In response to your requests dated December 22, 1975, January 29, 1976 and March 5, 1976, the Commission has issued the enclosed Amendment No. 21 to Facility Operating License No. DPR-27 for the Point Beach Nuclear Plant, Unit 2.

SUPPORTING AMENDMENT NO. 21 TO LICENSE NO. DPR-27

POINT BEACH NUCLEAR PLANT UNIT 2

Amendment No. 21
License No. DPR-27

Figure 15.2.1-1 Core DNB Safety Limits
Point Beach Unit 2

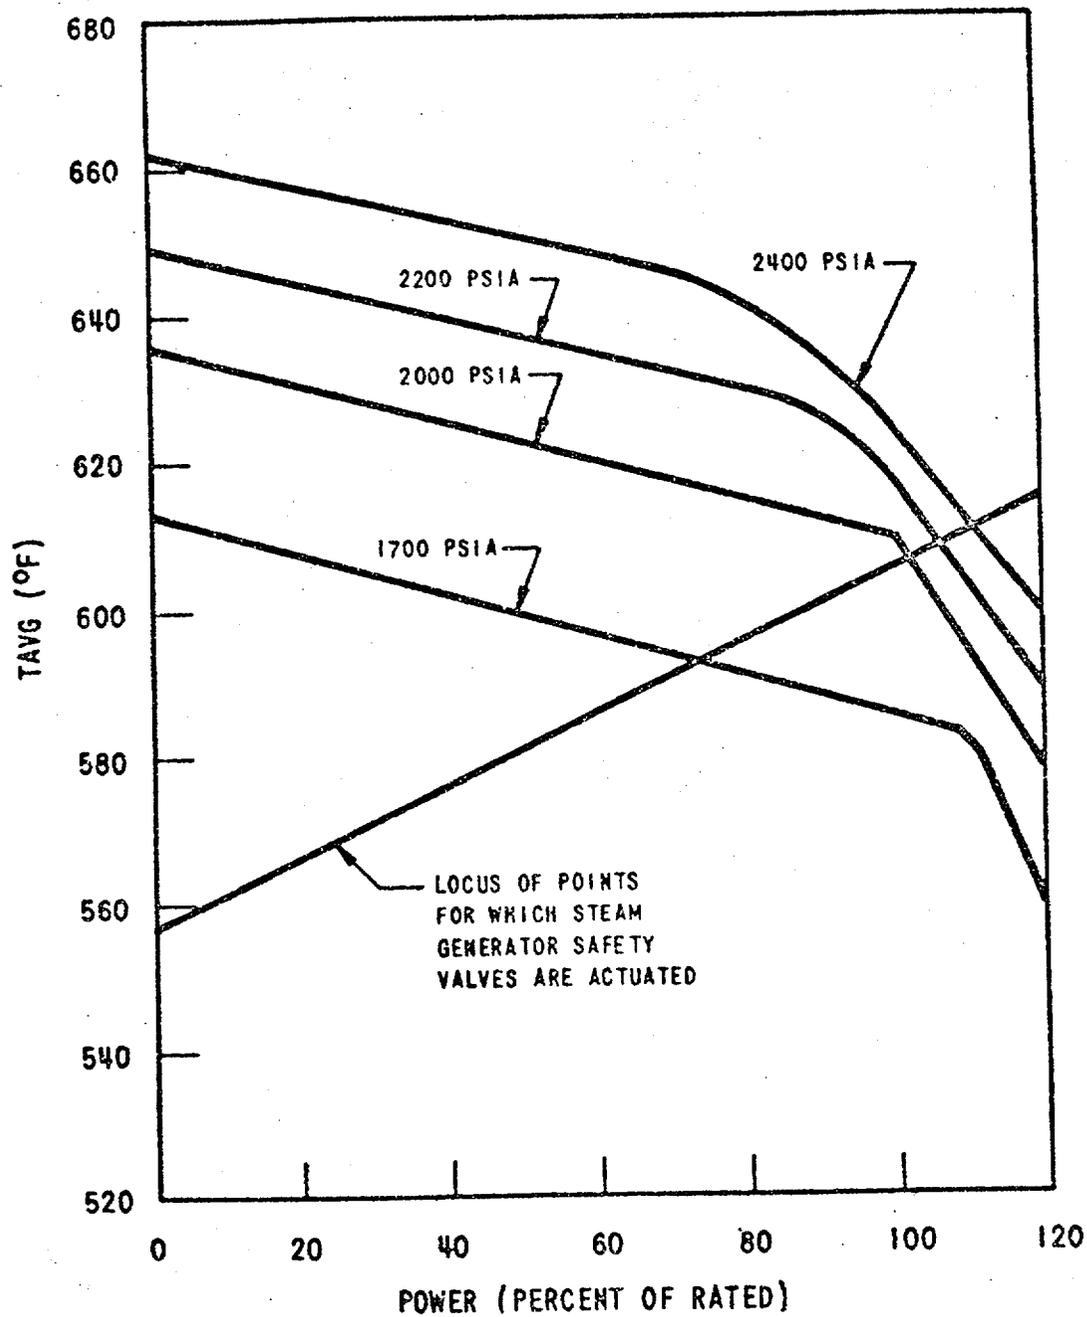
The curves of Figure 15.2.1-1 represent the loci of points of thermal power, coolant system pressure and average temperature for which the DNB ratio is no less than 1.30. The area of safe operation is below these lines. The safety limits curves have been revised to allow for heat flux peaking effects due to fuel densification and flattened fuel cladding sections.

Additional peaking factors to account for local peaking due to fuel rod axial gaps and reduction in fuel pellet stack length as well as a penalty to account for rod bowing, have been included in the calculation of the curves shown in Figure 15.2. These curves are based on an $F_{\Delta H}^N$ of 1.58, cosine axial flux shape, and a DNB analysis as described in Section 4.3 of WCAP-8050 "Fuel Densification, Point Beach Nuclear Plant Unit 1 Cycle 2", (including the effects of fuel densification and flattened cladding).

Figure 15.2.1-1 also includes an allowance for an increase in the enthalpy rise hot channel factor at reduced power based on the expression:

An additional rod bow penalty is applied for the Point Beach Unit 2 core Cycle 3 to limit the radial peaking factor $F_{\Delta H}$, to a more conservative value of 1.55 instead of 1.58. This additional penalty is based on new data (plus appropriate conservatisms) which shows that the bowing model in WCAP-8386, "An Evaluation of Fuel Rod Bowing" underestimates the extent of fuel rod bowing.

1. The combination of thermal power level, coolant pressure, and coolant temperature shall not exceed the limits shown in Figure 15.2.1-1. The safety limit is exceeded if the point defined by the combination of reactor coolant system average temperature and power level is at any time above the appropriate pressure line.
2. The fuel residence time of cycle 3 for Unit No. 2 shall be limited to 9,000 effective full power hours (EFPH) under design operating conditions, with a primary system pressure of 2,250 psia.
